**BusConnects Galway  
Cross City Link  
(University Road to  
Dublin Road)**

February 2023

**Galway City Council  
Observations on the  
Proposed Scheme  
Submissions and  
CPO Objections**

Figure 2.1 – Extract from EIAR General Arrangement Drawing at Galway Courthouse

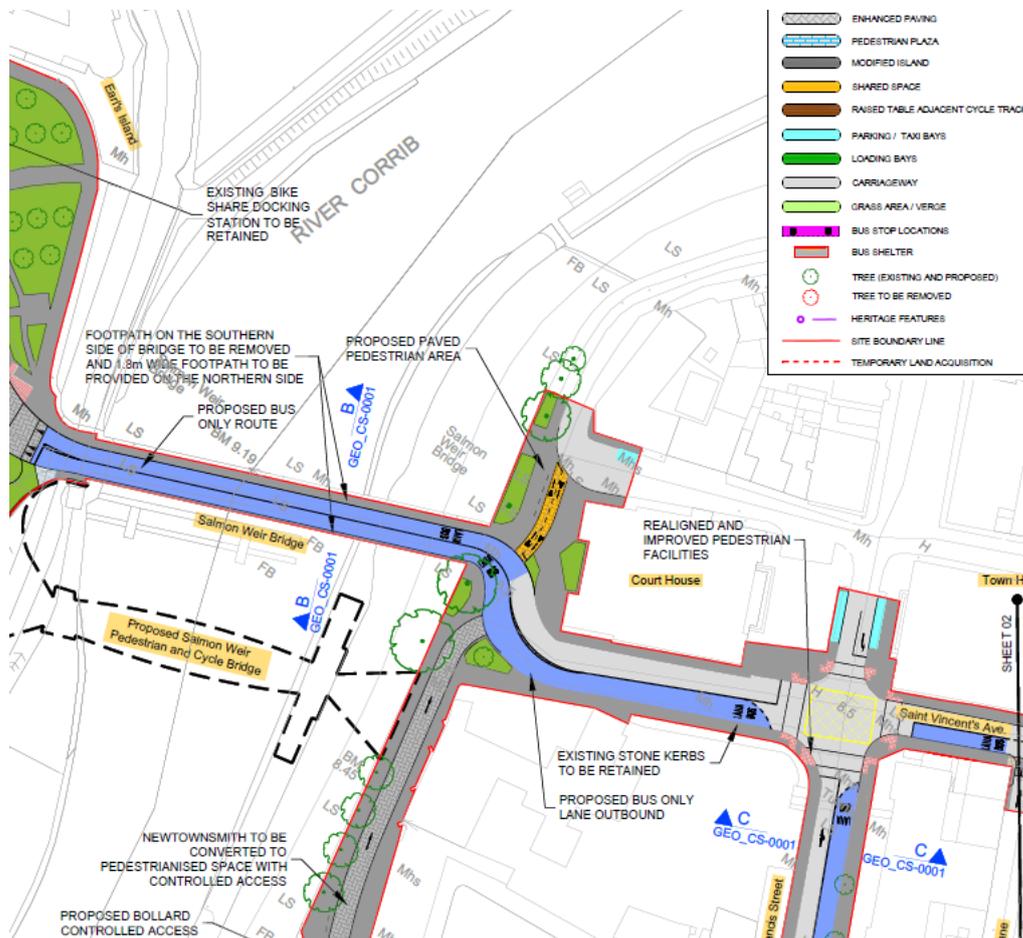
As the submission correctly identifies, Waterside is a part of the Proposed Scheme and there are bus lanes approaching this junction from both the east and the west, making this road inaccessible for general traffic. Should this route be retained in its current form, it would not be accessible, without driving in a bus lane. This was a primary rationale for the closure of this section of the routes, together with the creation of a pedestrian plaza. An extract of the General Arrangement layout for the Proposed Scheme in the vicinity of Waterside is presented below in Figure 2.1

Notwithstanding the above, and as included in the response to the submission made by the Courts Service in Section 2.22 of this report, having considered the proposed amendments as set out in the submission by the Courts Service, Galway City Council have no objection to, and would support An Bord Pleanála making a condition to the grant of planning permission which would amend the Proposed Scheme in the vicinity of Galway Courthouse. Galway City Council suggest the following amendments, subject to the approval of An Bord Pleanála:

The proposed scheme shall be amended in the vicinity of Galway Courthouse, as per drawing BCG-GA-00-02-PL02.

Figure 2.2 – Extract from Proposed General Arrangement Drawing at Galway Courthouse

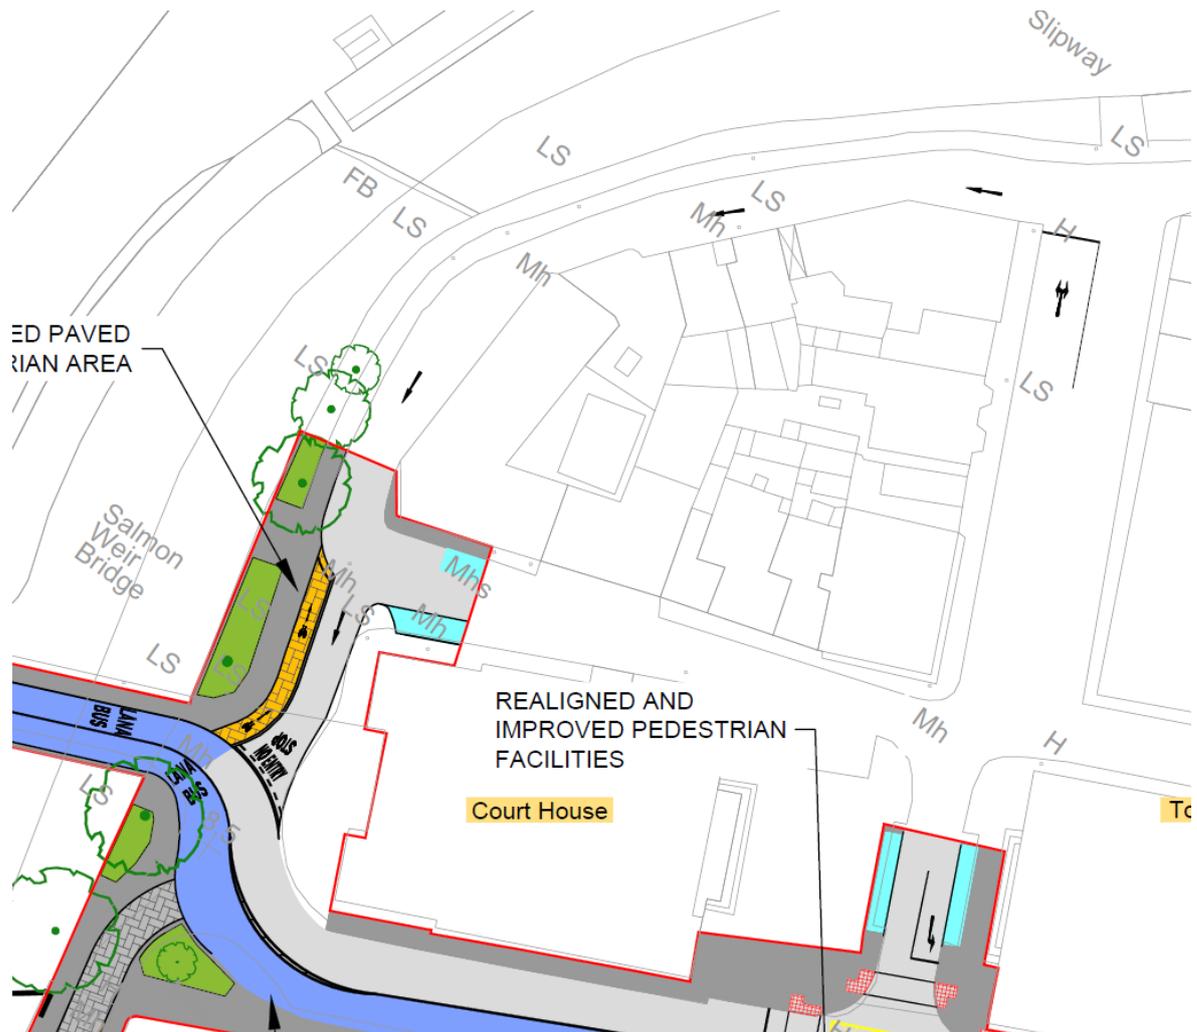
A General Arrangement sketch, extracted from drawing BCG-GA-00-02-PL02, which is contained in Appendix A of this report, of the proposed layout in the vicinity of the back of the Courthouse is presented in Figure 2.2

The proposed amendment will remove plot 126.a.101 from the Compulsory Purchase Order Schedule Part I and plot BB from the Compulsory Purchase Order Schedule Part III (Section B).

Figure 2.3 – Extract from Proposed General Arrangement at Eyre Square North

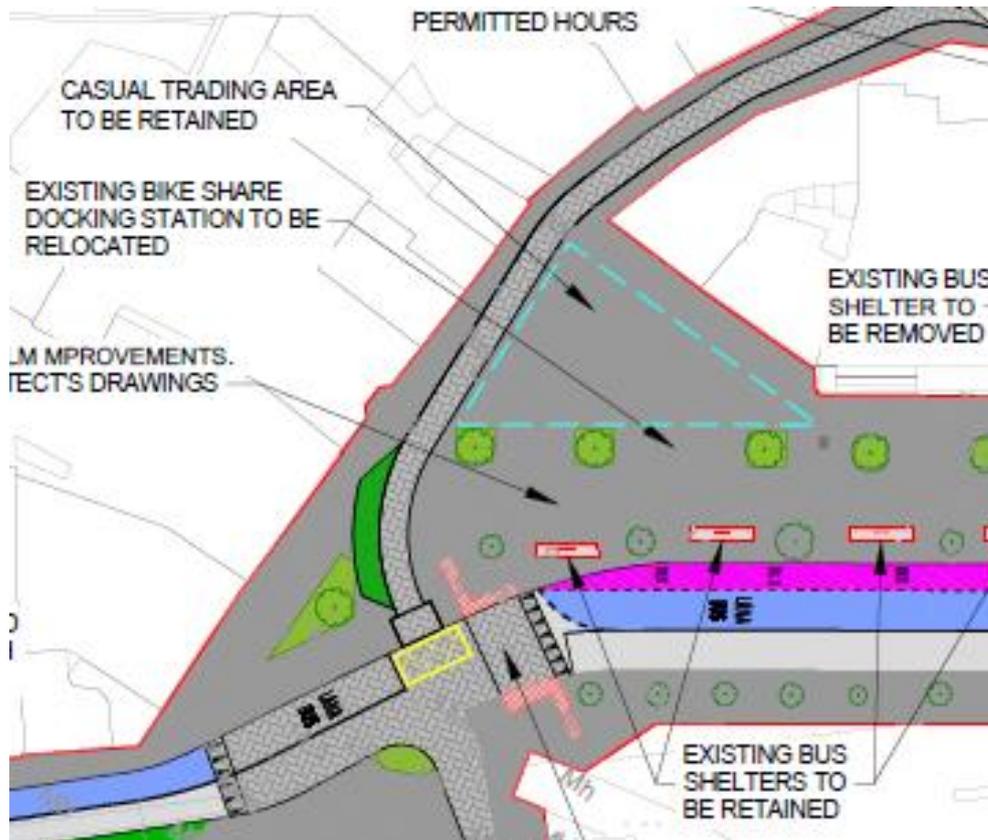
Upon consideration of the concerns of the Devaney Family and other submissions received relating to the Proposed Scheme, Galway City Council will not object to amending the proposed scheme requiring the casual trading area to remain in its current location, should An Bord Pleanála consider this appropriate. Galway City Council suggest that this potential amendment to the proposed scheme can be dealt with by way of a condition of planning, stating that the proposed scheme shall be amended in the vicinity of Eyre Square North, as per drawing BCG-GA-00-04-PL02.

It will require the removal of a proposed landscaped area in the vicinity of the existing casual trading area and the relocation of the proposed loading bay to a location south-west of that proposed in the current scheme.

This suggested change to the proposed development will reduce the number of trees to be planted across the scheme by 9, from 186 to 177. This change is deemed to be not significant at a local and on a scheme-wide basis; no additional significant impacts are likely. Impacts relating to the displacement of traders at this location will not now occur in the longer term.

Figure 2.4 – Existing Taxi Rank Operatoin at Eyre Square

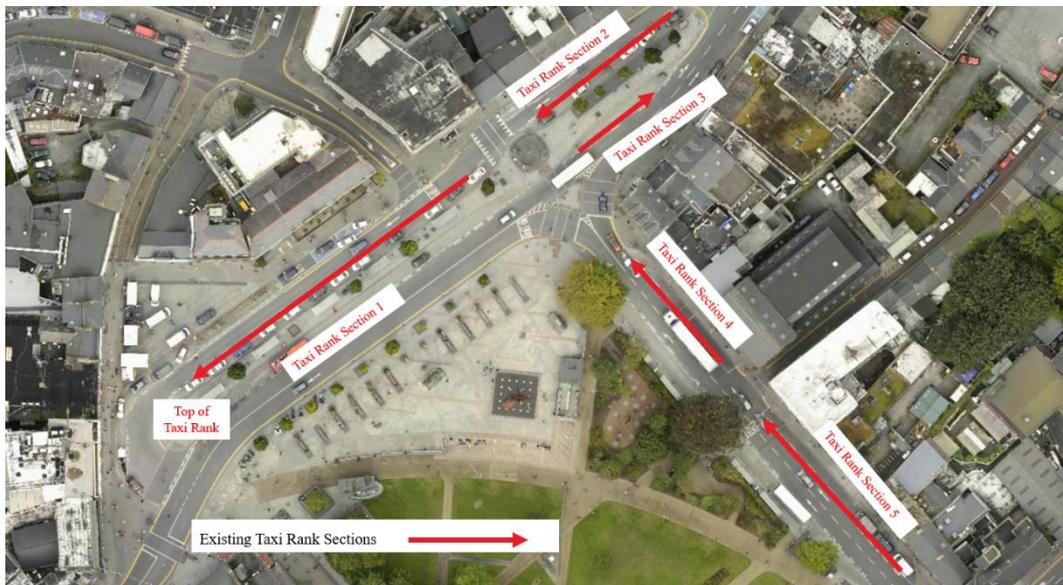
Due to the proposed removal of the road located between Eyre Square North and Bank of Ireland, and the creation of an enhanced public realm plaza combined with the cul-de-sac of Prospect Hill at its interface with the Cross-City Link, amendments to the existing taxi rank(s) are necessary as part of the Proposed Scheme. Appendix C of the Preliminary Design Report, the Preliminary Parking Survey Report' together with the Road Marking and Signage design drawings submitted as part of this planning application contain design information pertaining to the proposed accommodation of taxi ranks.

The existing, combined taxi rank along Eyre Square has capacity for approximately 39 taxis. The standard operation of this rank sees taxis joining the back of the queue at the rank via Eyre Square East, with the queue infrequently snaking along Eyre Square East, Prospect Hill and Eyre Square North. The head of the queue is located on Eyre Square North, opposite Supermacs. An indication of the existing taxi rank operation is presented below in Figure 2.4

The Proposed Scheme would have three separate taxi ranks, one on Prospect Hill (comprising of three bays), one on Eyre Square East (comprising of 2 bays) and one on Eyre Square South (comprising of one bay). Combined, these three ranks will have capacity for approximately 26 taxis. Passengers will have a choice on which taxi rank to use, likely dependant on their proximity and/or destination.

Figure 2.5 – Retained Laneway at No. 3 Headford Road

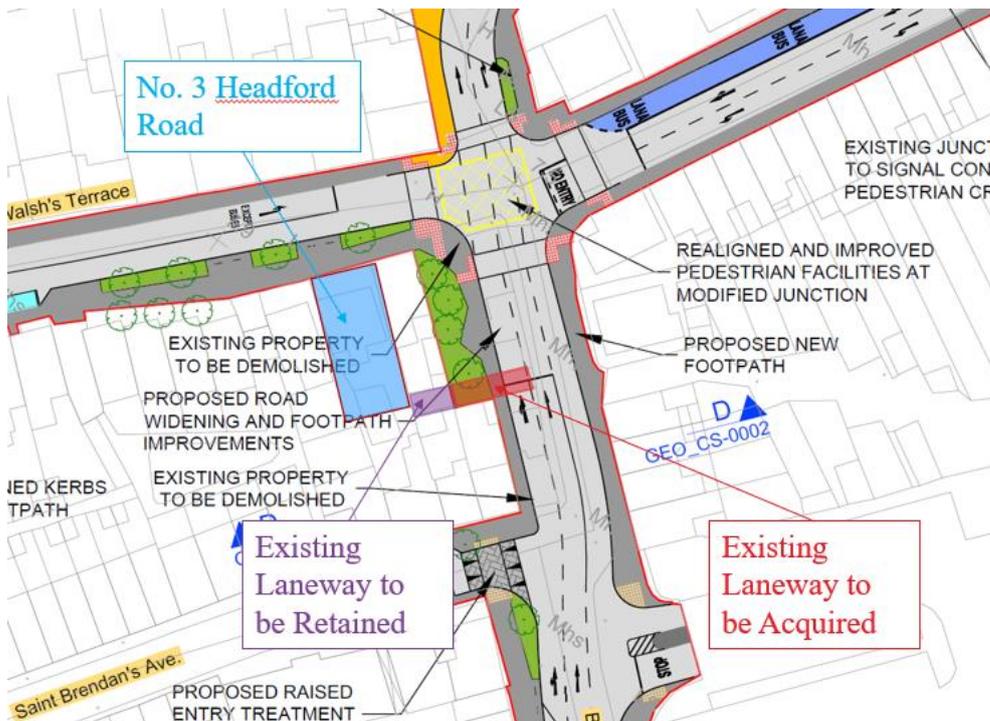
The submission suggests that the proposed scheme will lead to increased noise, fumes and light pollution to the rear of the property, loss of privacy to the rear of the property, increased security to the rear of the property, safety issues from the laneway over a road and vice versa by foot and bicycle, and inconvenience assuming a revised bin collection from the front of the property and oil deliveries, overlooking.

It is the understanding of Galway City Council that the rear of the property is accessed via an existing laneway from St. Brendan’s Avenue, which ends at the rear of No. 3 Headford Road and No. 17. St. Brendan’s Avenue. The Proposed Scheme intends to acquire part of this laneway, directly to the rear of No. 5/6 Headford Road, for the purposes of realigning St. Brendan’s Avenue. Access to the remainder of the laneway is not proposed to be altered. Figure 2.5 provides an extract from Drawing BCG-GA-00-03 of the Proposed Scheme in this location. No. 3 Headford Road has been highlighted in blue for clarity. The section of laneway to be retained has also been identified. Access to and from the laneway will continue to be permitted across what would become public lands.

Figure 2.7 – Extract from Proposed General Arrangement at Galway Courthouse

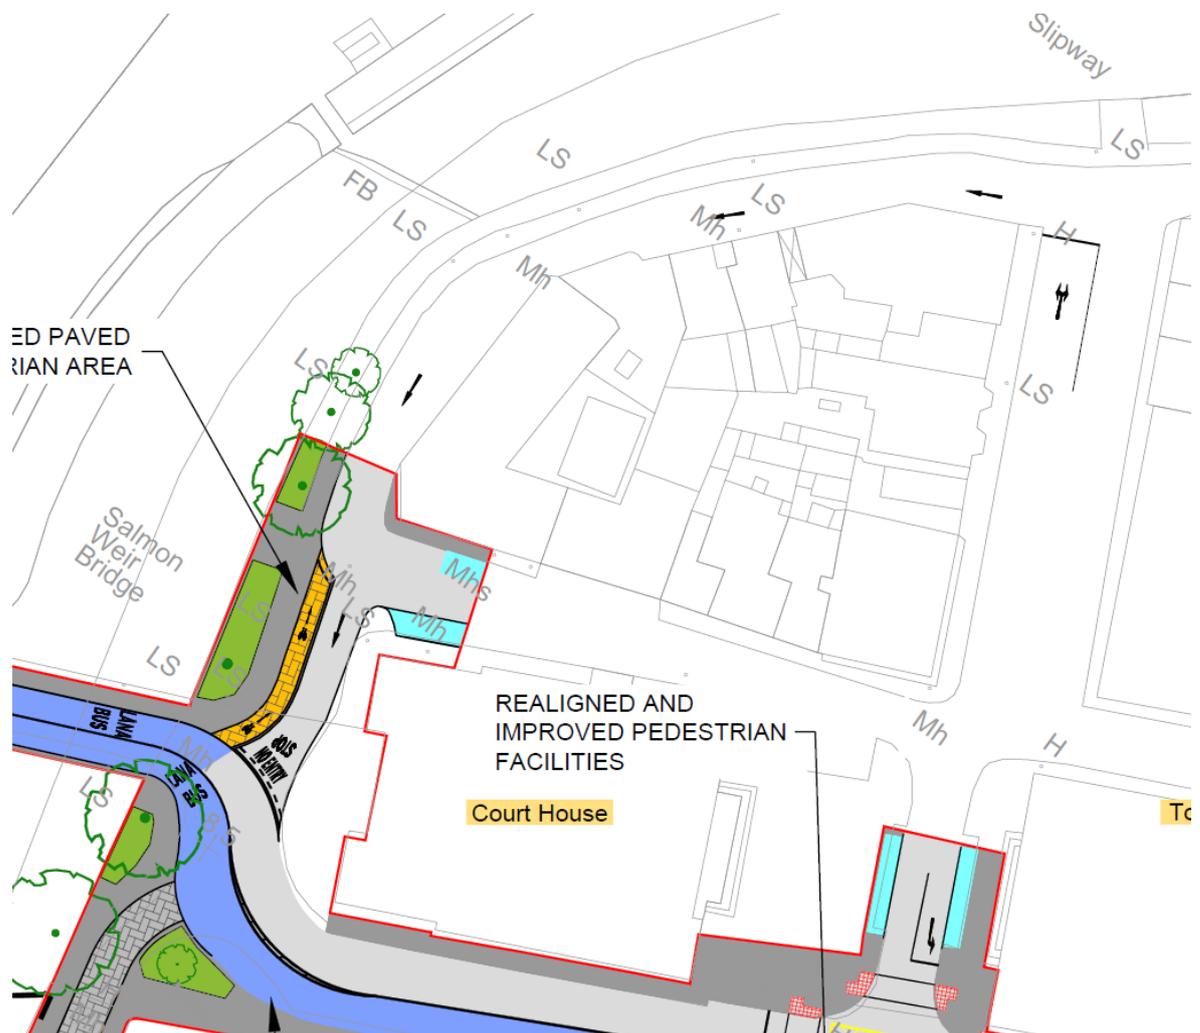
The proposed scheme shall be amended in the vicinity of Galway Courthouse, as per drawing BCG-GA-00-02-PL02.

The proposed amendment will remove plot 126.a.101 from the Compulsory Purchase Order Schedule Part I and plot BB from the Compulsory Purchase Order Schedule Part III (Section B).

This suggested change to the proposed development will reduce the number of trees to be planted across the scheme by 1, from 186 to 185. In addition, the change to the proposals at this location will result in a reduction in proposed new green space (43m<sup>2</sup>). This change is deemed to be not significant at a local and on a scheme-wide basis; no additional significant impacts are likely.

Figure 3.4 – Extract from Proposed General Arrangement at Galway Courthouse

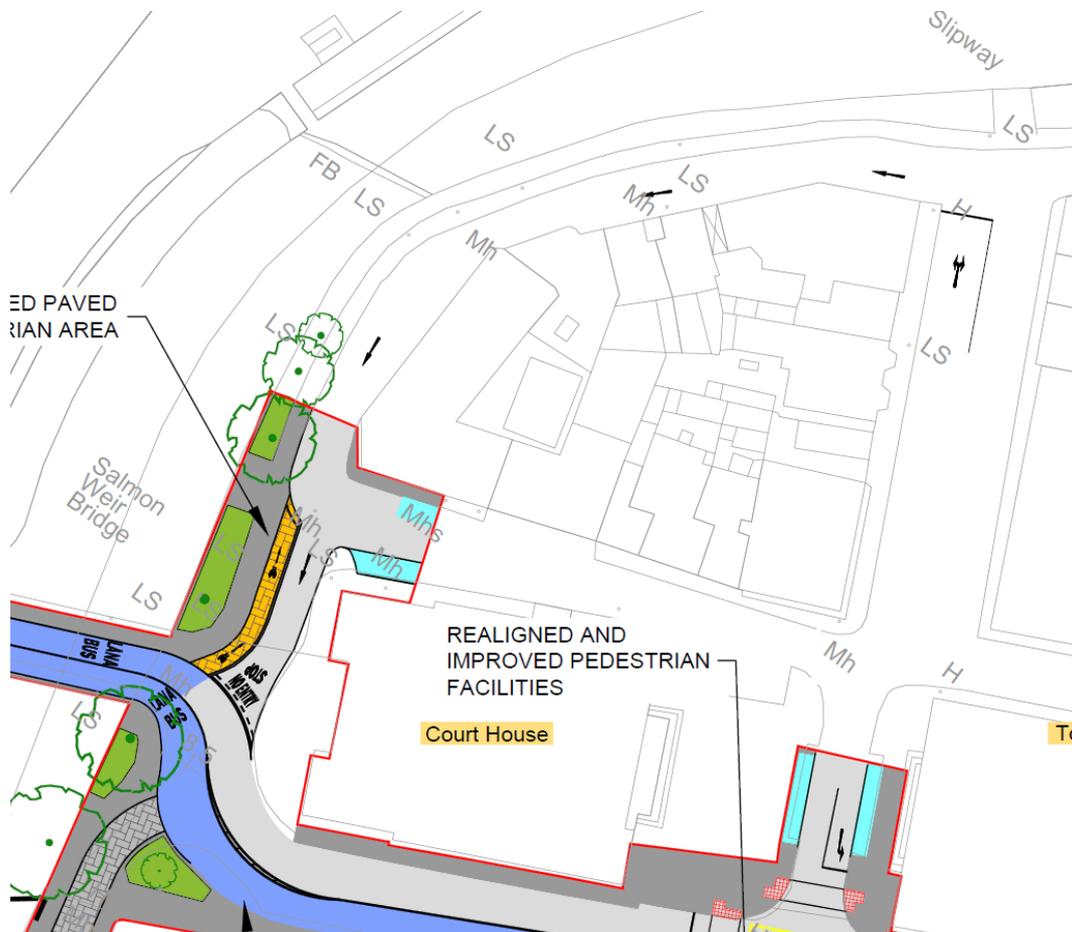
- No alterations to the existing footpath and parking under the ownership of Galway Courthouse be proposed.

A potential General Arrangement sketch of this suggested layout in the vicinity of the back of the Courthouse is presented in Figure 3.4

Should An Bord Pleanála take into consideration the proposals suggested by Galway City Council above, it is proposed by GCC to amend the extents of the proposed scheme, to remove any proposed adjustment to Galway Courthouse property. This would have the effect of removing Galway Courthouse (Plot 126.a.101 Schedule Part I) from the Compulsory Purchase Order.
